Access Compliance Report

Public Rights-of-Way

(Curb Ramps)

Intersection ID: 48569	Main Street: RED_SQUIRREL_TL	Cross Street: SALAMANDER_RUN_LN	Location: SW
ADA ID: 45079122C981	Ramp Type: PerpDiag	Initial Pass/Fail: Pass	Overall Compliance: No
			Severity Score: 12.75

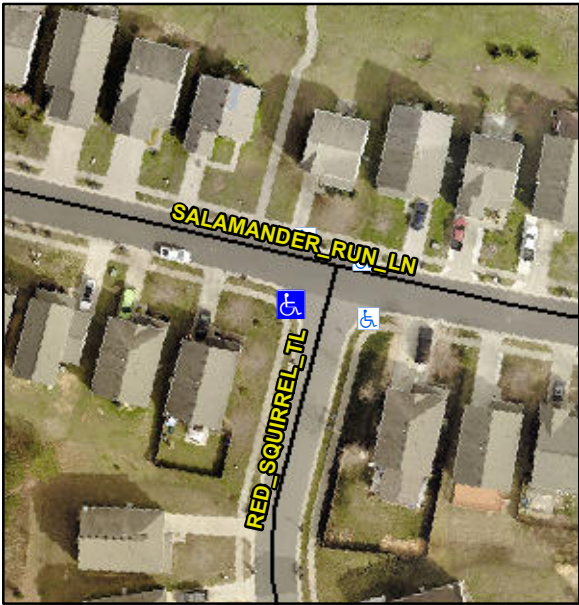
Codes/Mitigation Info/Possible Solution			Field Measurements/Component Compliance					
	Possible Solutions:		Compliance	Description	Data	Compliance	Description	Data
	Remove & Replace Curb Ramp With Two New Directional Ramps or Equivalent. Remove & Replace Gutter.		N/A	Ramp Length (in)	46.0	Yes	Ramp Slope (%)	7.8
			Yes	Ramp Width (in)	48.0	No	Ramp XSlope (%)	3.8
			N/A	Flare Type LT	Sloped	N/A	Flare Type RT	N/A
			N/A	Flare Slope LT (%)	2.4	Yes	Flare Slope RT (%)	5.4
			N/A	Flare Traversable LT?	Yes	N/A	Flare Traversable RT?	Yes
			No	Landing Length (in)	47.5	Yes	DWS Provided?	Yes
			Yes	Landing Width (in)	65.0	Yes	DWS Contrast?	Yes
			Yes	Landing Slope (%)	1.8	Yes	DWS Length (in)	24.5
			No	Landing X Slope (%)	5.8	Yes	DWS Full Width?	Yes
Surveyor Notes:		N/A	N/A	Landing Curb? (Y/N)	No	No	DWS Offset (in)	3.0
PROW/ADA:		Not Found, R304.5.3, R304.2.1, R305.2, R302.7, R302.7.2, R304.5.4	N/A	Shared Landing?	No

No	Gutter Ponding?	Yes	No	Gutter Slope (%)	12.5
			No	Gutter Lip Ht (in)	0.5	No	Gutter X Slope (%)	3.0
			N/A	Painted X Walk1?	No	N/A	Painted X Walk2?	No
				X Walk 1 Direction	To E		X Walk 2 Direction	To N
			N/A	X Walk 1 Width (in)	N/A	N/A	X Walk 2 Width (in)	N/A
				X Walk 1 Slope (%)	1.1		X Walk 2 Slope (%)	0.8
				X Walk 1 X Slope (%)	2.9		X Walk 2 X Slope (%)	2.8
			N/A	Ramp inside XWalk1?	N/A	N/A	Ramp inside XWalk2?	N/A
				Road Slope (%)	2.9	N/A	Clear Space?	Yes
				Road X Slope (%)	3.4	N/A	Clear Space to XWalk (in)	N/A
			Yes	Any Obstructions?	No	Yes	Storm Grate/Utility Hazard?	No
				Obstruction Type			Storm Grate/Utility Type	
						N/A		N/A
						Yes	Surface Condition? (G/P)	Good
